COSGROVE SUBDIVISION

APPLICATION NUMBER 2 DATE August 8, 2013
APPLICANT Cosgrove Subdivision
REQUEST Subdivision

DETAIL SITE PLAN

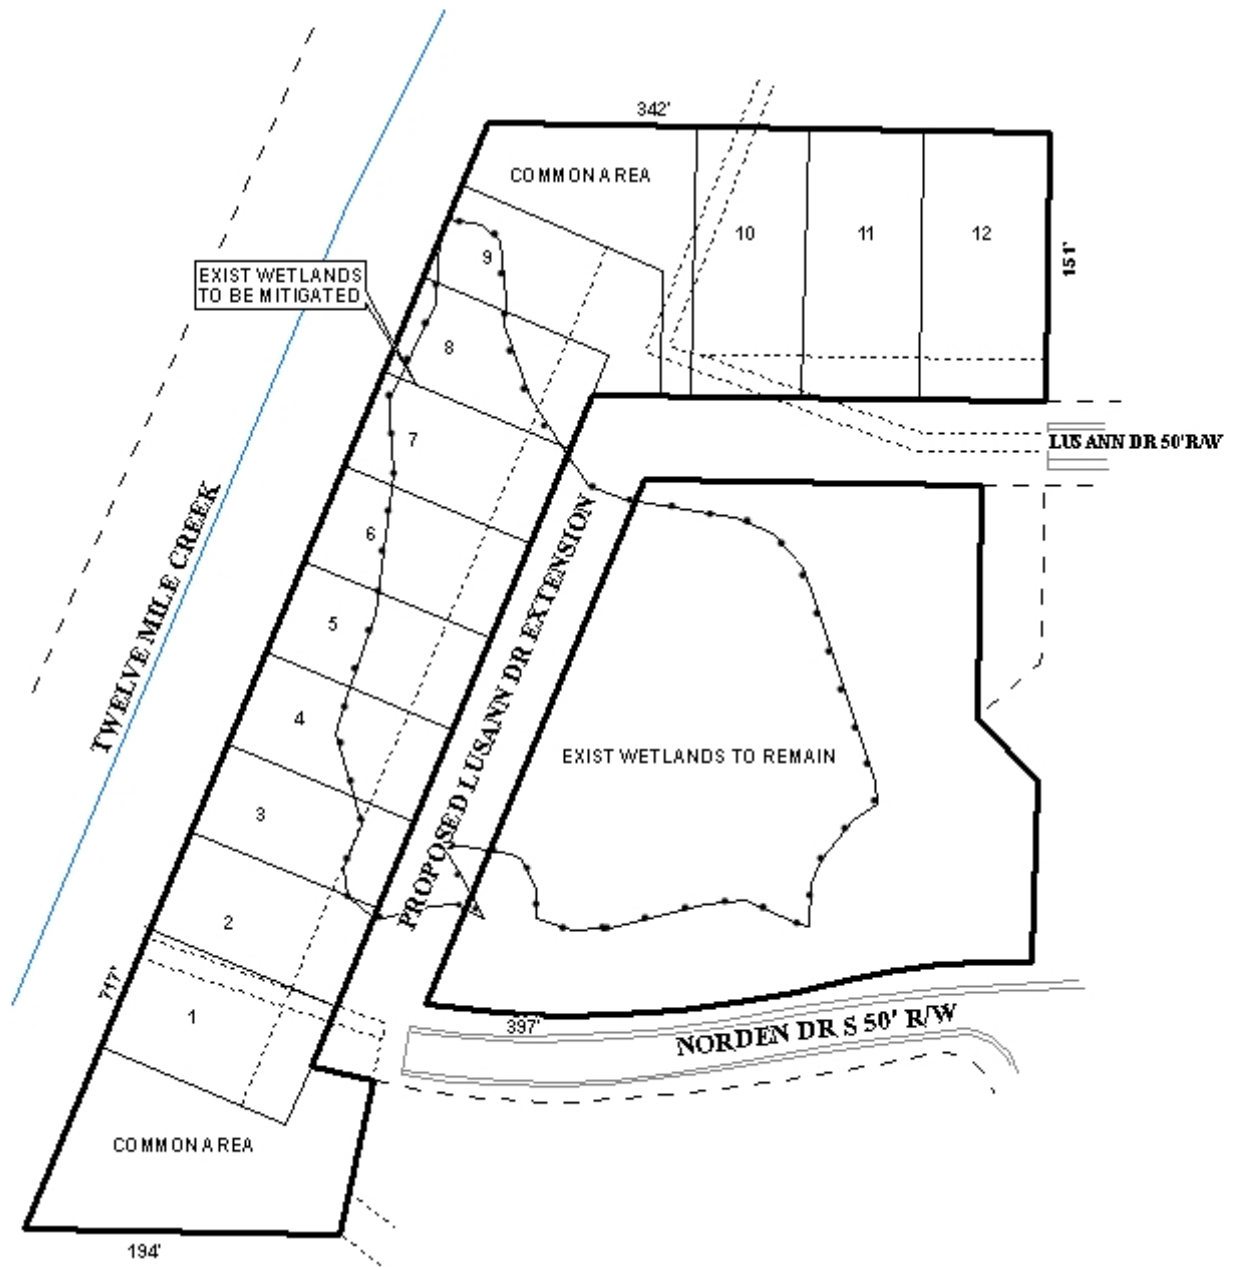
The site fronts onto two minor streets: Norden Drive South and Lusann Drive. Each of the existing streets have adequate rights-of-way. The development includes the construction of an extension of Lusann Drive, and the proposed right-of-way will comply with the minimum width requirements for streets with curb and gutter. Any new road construction must comply with Engineering Department requirements.

It should be pointed out that Section V.B.12. of the Subdivision Regulations requires that the minimum radius of curvature of streets on the centerline shall be 100 feet for a minor street. As this is a new minor street, the plat should be revised to comply with these requirements.

The applicant is proposing 12 lots. Each lot will meet the minimum area requirement for properties served by water and sewer systems. All lots, with the exception of Lots 1, 8 and 9, will meet the minimum frontage width requirement of 60-feet. Proposed Lots 1, 8 and 9 are located at curves of the new road, thus the lots will only have 35 to 40 feet of frontage, however, the lots quickly widen to 60-feet in width. As proposed, a waiver of Section V.D.2. regarding minimum lot width will be required.

The 25-foot minimum setback line is depicted for all lots and should be retained on the final plat, if approved.

Access management is a concern due to the fact that each lot will have limited frontage. Each lot should be limited one curb-cut each, with the size, design and location to be approved by Traffic Engineering and conform to AASHTO standards. Common areas are also proposed, and in order to facilitate access for maintenance, each common area should be limited one curb-cut each, with the size, design and location to be approved by Traffic Engineering and conform with AASHTO standards.

Multiple drainage and sanitary sewer easements exist on the site. A note should be placed on the final plat, if approved, stating that no structure may be built within any easements.

As common areas and detention basin common areas are proposed for the subdivision, a note should be placed on the Final Plat, if approved, stating that maintenance of the detention basin common areas, and any other common areas, are the responsibility of the subdivision's property owners.

- 1) Revision of the plat to reflect compliance with Section V.B.12. of the Subdivision Regulations regarding the minimum radius of curvature of minor streets;

- 2) All new road construction must comply with Engineering Department requirements;
- 3) Placement of a note on the final plat stating that each lot and common area is limited to one (1) curb-cut each, with the size, design and location of all curb-cuts to be approved by Traffic Engineering and conform to AASHTO standards;

- 4) Placement of a note on the final plat stating that no structure may be built within any easements;
- 5) Depiction of the 25-foot minimum building setback line from all street frontages as required by Section V.D.9. of the Subdivision Regulations;

- 6) The labeling of each lot with its size in square feet, or placement of a table on the plat with the same information;
- 7) Labeling of all common areas, including detention common areas, and placement of a note on the final plat stating that the maintenance of the common areas is the responsibility of the property owners;
